Final Commissioning Report For Woodland High School

Commissioning Issues Report

Project: Woodland High School

WOODLAND HIGH SCHOOL CX OPEN ISSUES

Issue ID M-31—AHU-1 moves to incorrect minimum damper position.

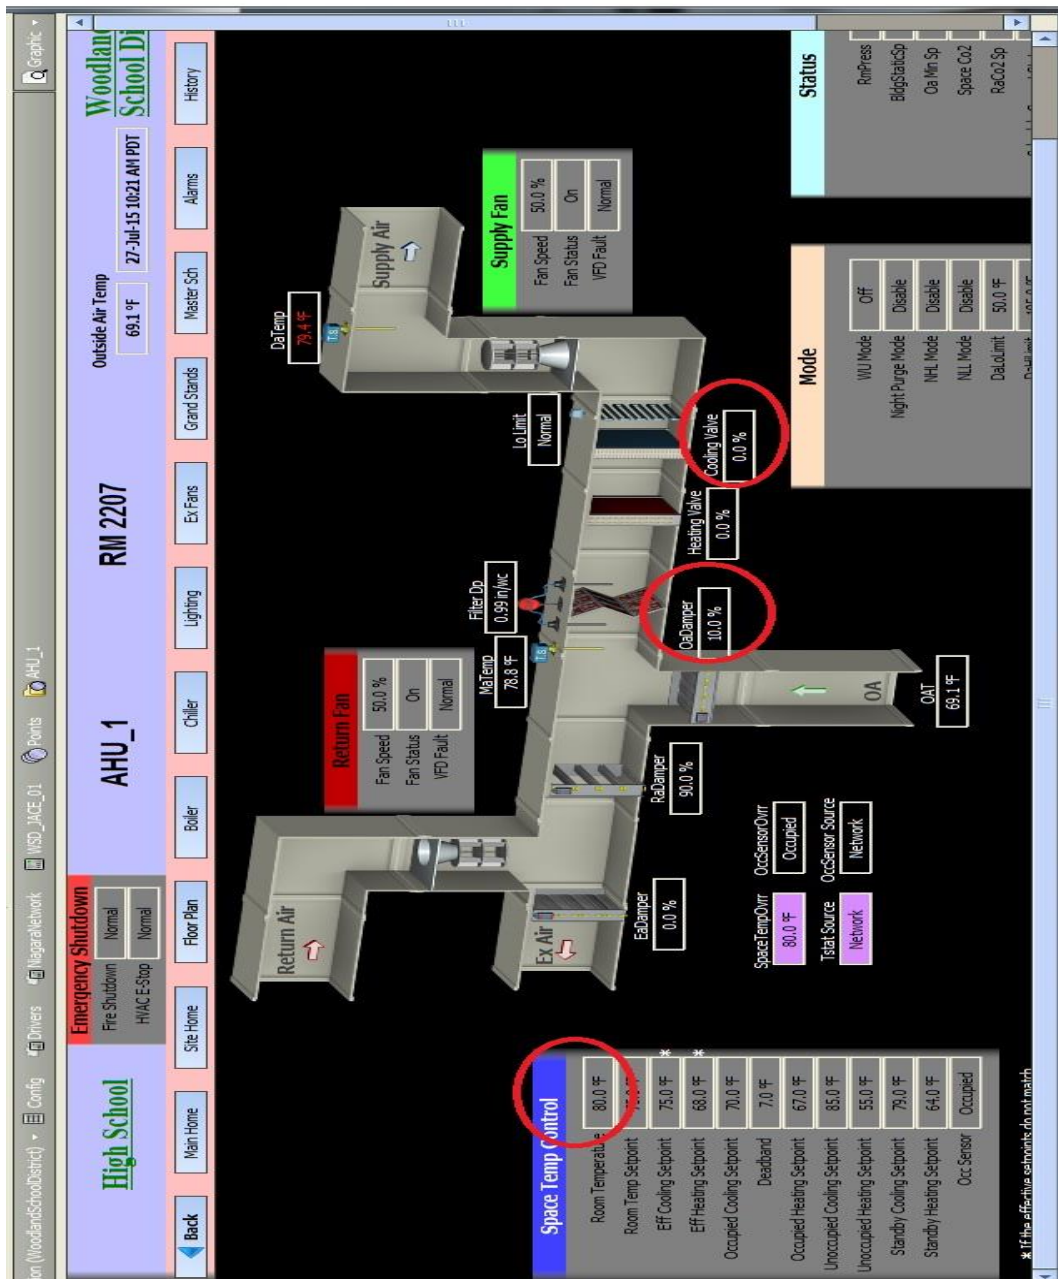
Specialists in School Buildings

Issue M-33 and M-34—HRU-8 room static pressure reading is -.05" with all equipment off. The CO₂ reading is not being displayed accurately.

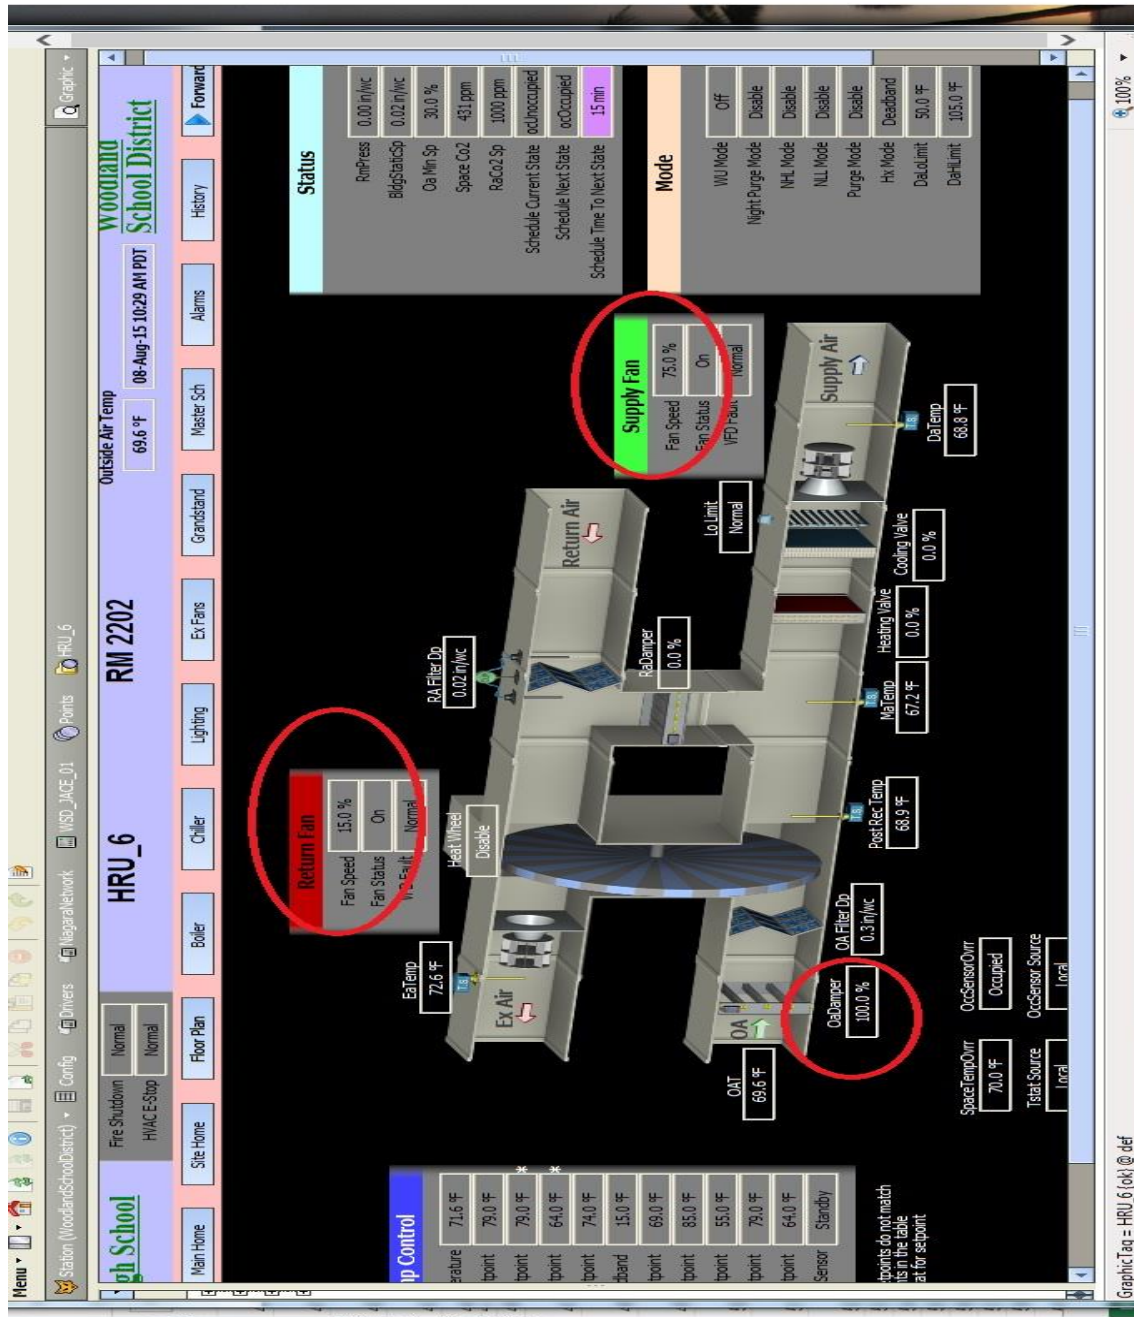
M-33	07.28.15-- HRU-8 CO2 sensor display is not an accurate representation of CO2 levels. The DDC system graphics displays 64435 ppm.	NCC will verify and re-calibrate any room space temperature/CO2 sensors are properly calibrated within the tolerances allowed per the design.	Joe Barnes with NCC determined this was due to the wrong graphic display being used. This space does not have CO2 control as part of the design. CSG verified the display was corrected.	08.27.15
M-34	07.28.15-- HRU-8 Space pressure display is not accurate. With the entire HVAC system in unoccupied mode and off, the space static pressure is reading a -.50".		NCC determined the sensor was properly linked with the controller. CSG verified the space pressure being sensed in the space was accurately represented and the associated sequence of operations worked correctly for managing space pressurization.	08.27.15
M-35	07.28.15-- We discovered the occupancy sensor source for AHU-12 was overridden to "Network". Can NCC verify whether this is correct and report back what the setting should be?		Joe Barnes explained this was a setting from which a choice is made regarding the source for inputs from each room space sensor. He assured CSG the correct settings will be programmed into every AHU. CSG verified this to be true and they were all identical.	08.27.15

Issue ID M-36—HRU 6 was found running during unoccupied hours on a Sat morning. We notice an override is on regarding the next change of state.

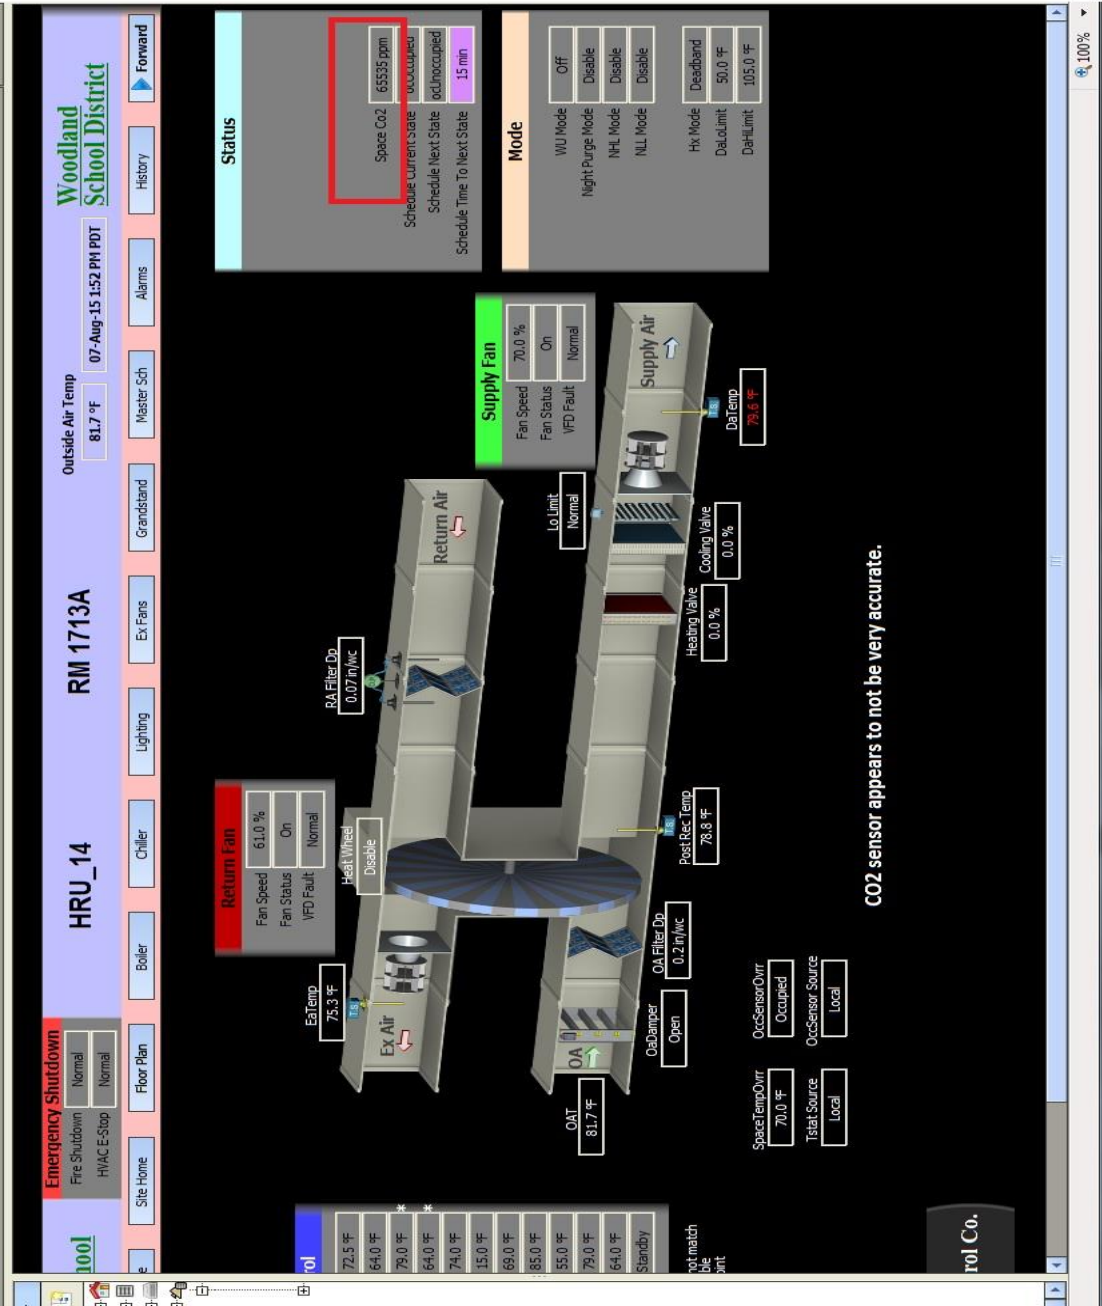
M-36	07.28.15-- HRU-6 was discovered running at 10:28AM on Sat AM during unoccupied mode. We noted on the Status display, the "scheduled time to next state" appears to have an override of 15 minutes entered. Can NCC verify whether this is correct and report back what the setting should be?	08.14-15-- Joe has set up trends on this HRU to review whether this continues to be an issue or not.	NCC released all overrides. Trends for HRU-6 revealed it has been cycling on and off according to the Woodland School District's normal schedule of operation.	09.11.15

Issues ID M-37 & M-38—HRU-14 CO2 sensor is not being displayed accurately.

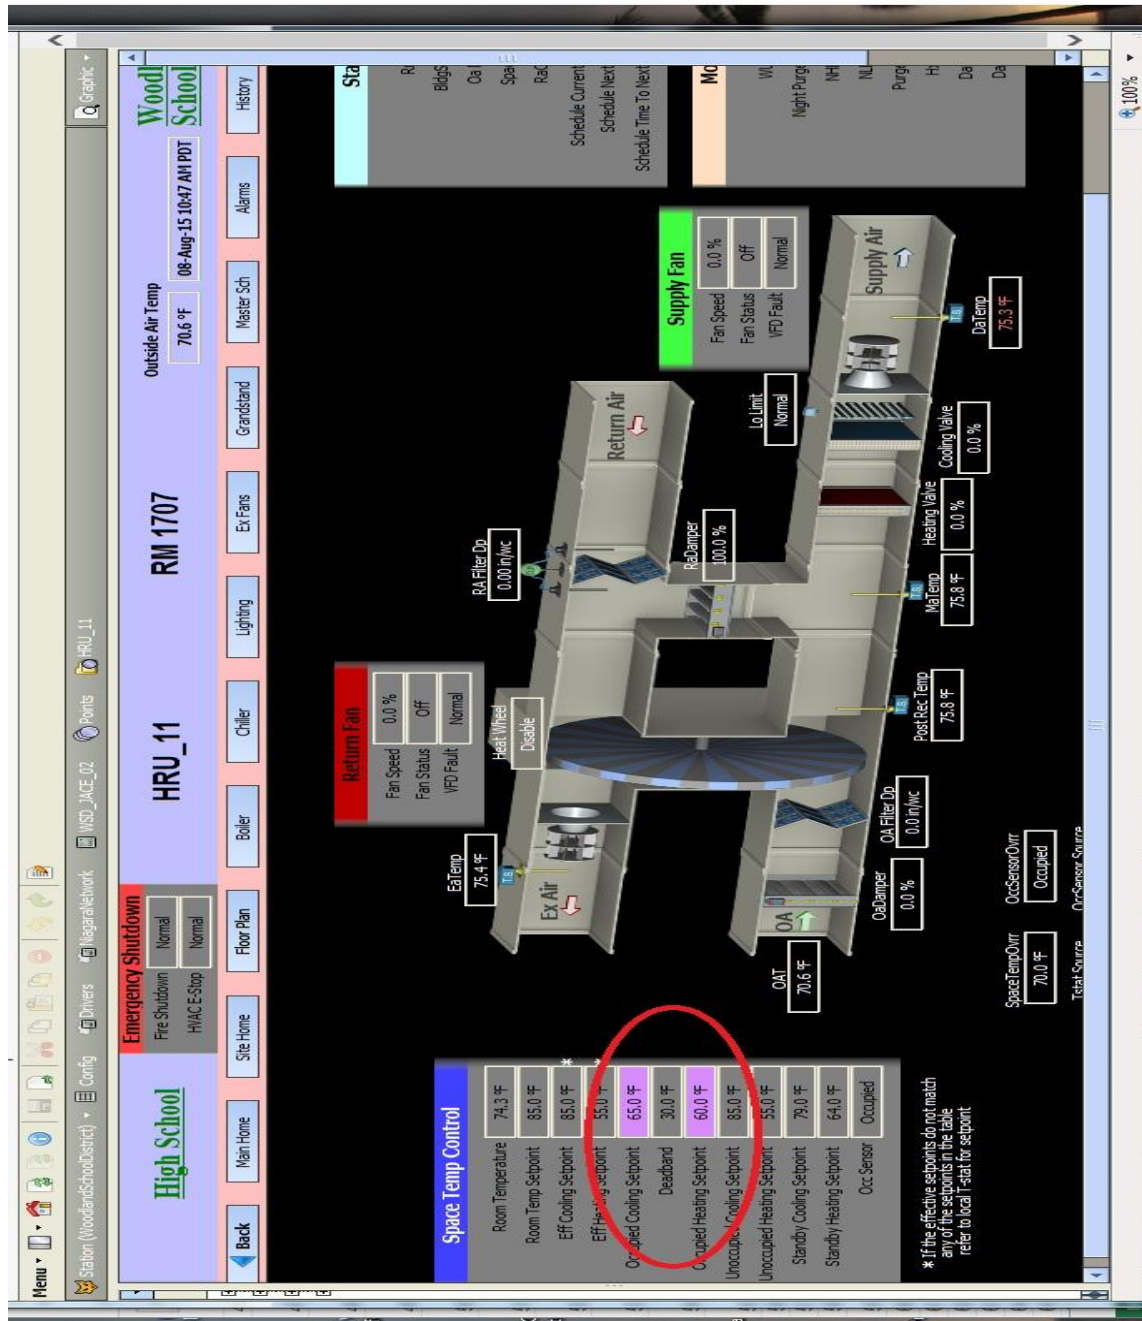
ID	Summary	Proposed Resolution	Actual Resolution	Date resolved
M-37	07.28.15-- HRU-14 CO2 sensor display is not an accurate representation of CO2 levels. The DDC system graphics displays 64435 ppm.	NCC will verify and re-calibrate any room space temperature/CO2 sensors are properly calibrated within the tolerances allowed per the design.	This was due to the wrong graphic display being used. This space does not have CO2 control as part of the design because the HRU always provides 100% fresh air. Graphic replaced.	08.27.15
M-38	07.28.15-- HRU-15 CO2 sensor display is not an accurate representation of CO2 levels. The DDC system graphics displays 64435 ppm.	NCC will verify and re-calibrate any room space temperature/CO2 sensors are properly calibrated within the tolerances allowed per the design.	This was due to the wrong graphic display being used. This space does not have CO2 control as part of the design because the HRU always provides 100% fresh air. Graphic replaced.	08.27.15

Issue M-39—HRU 11 heating and cooling set points have been overridden.

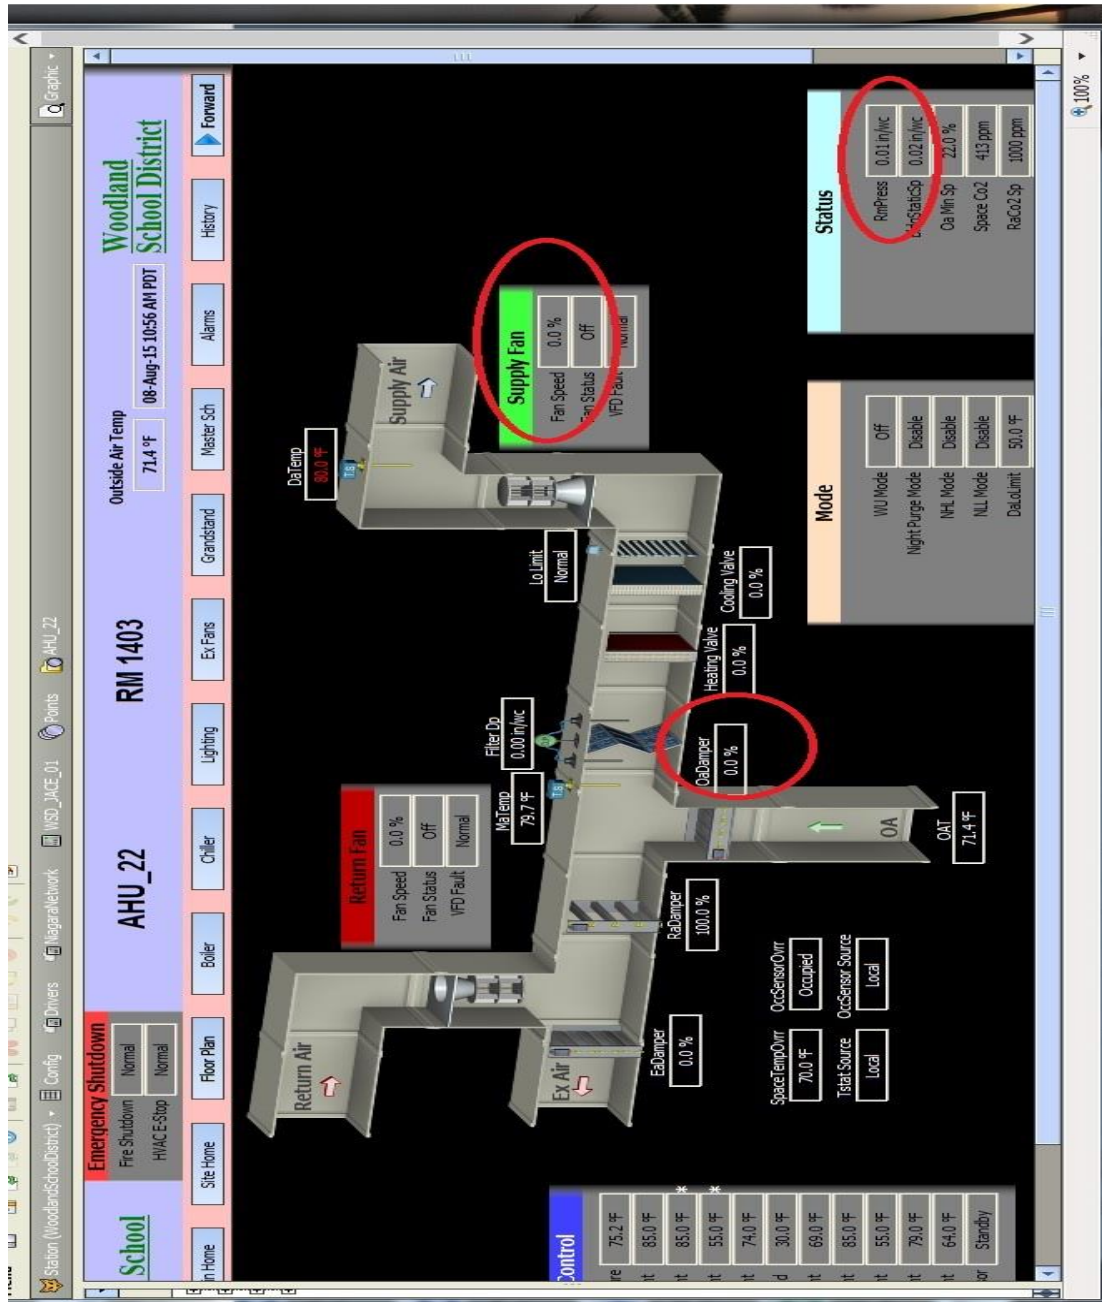
39	M-39	07.28.15	HRU-11 overridden	We discovered the cooling and heating set points overridden. Can NCC verify whether this is correct?	NCC	Closed
40	M-40	07.28.15	HRU-16 CO2 sensor	HRU-16 CO2 sensor display is not an accurate representation of CO2 levels.	NCC	Closed
41	M-41	08.08.15	AHU-22 Space pressure sensor	With the entire HVAC system in unoccupied mode and off, the space static pressure is reading a .01" which is not accurate.	NCC	Closed
42	M-42	08.08.15	ERU-1 sequence of operations	ERU-1 serving the Grandstands was found in occupied mode and running on Sat at 11:00 am when all HVAC equipment should remain off.	NCC	Closed
43	M-43	08.08.15	Chiller graphics	Although the chilled water system is off, the graphics reflect the condenser fans as running.	NCC	Closed

ISSUE M-48- AHU-39 OSA not moving to programmed minimum damper position.

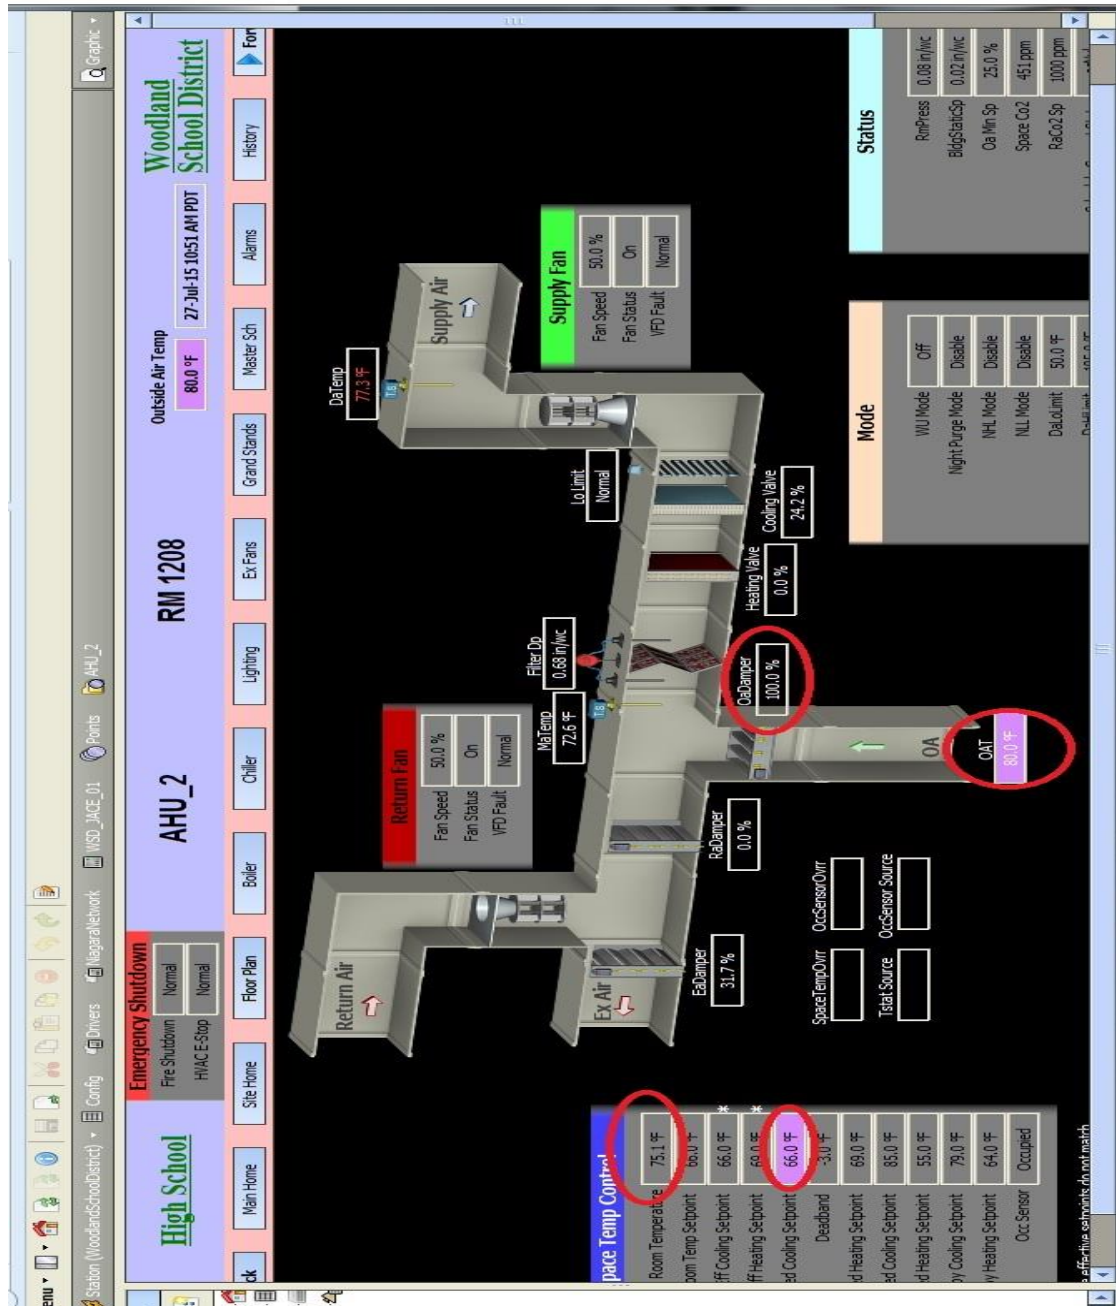
48	M-48	07.28.15	AHU-39 sequence of operations	AHU-39 outside air damper does not move to programmed minimum position of 18% and instead only moves to 10% open.	NCC	Closed
49	M-49	07.28.15	AHU-2 sequence of operations	During the clg sequence, the outside air damper economized 100% open even though the outside air temp was > return air temp.	NCC	Closed
50	M-50	07.28.15	AHU-2 sequence of operations	AHU-2 outside air damper does not move to programmed minimum position of 25% and instead moves to 10% open.	NCC	Closed
51	M-51	07.28.15	AHU-1 sequence of operations	During the heating sequence, the outside air damper moved to 0% position and the heating valve never opened.	NCC	Closed
52	M-52	07.28.15	AHU-5 sequence of operations	During the cooling sequence, the outside air damper economized 100% open even though the outside air temperature was higher than return air temperature.	NCC	Closed
53	M-53	07.28.15	AHU-7 sequence of operations	During the cooling sequence, the outside air damper economized 100% open even though the outside air temperature was higher than return air temperature.	NCC	Closed
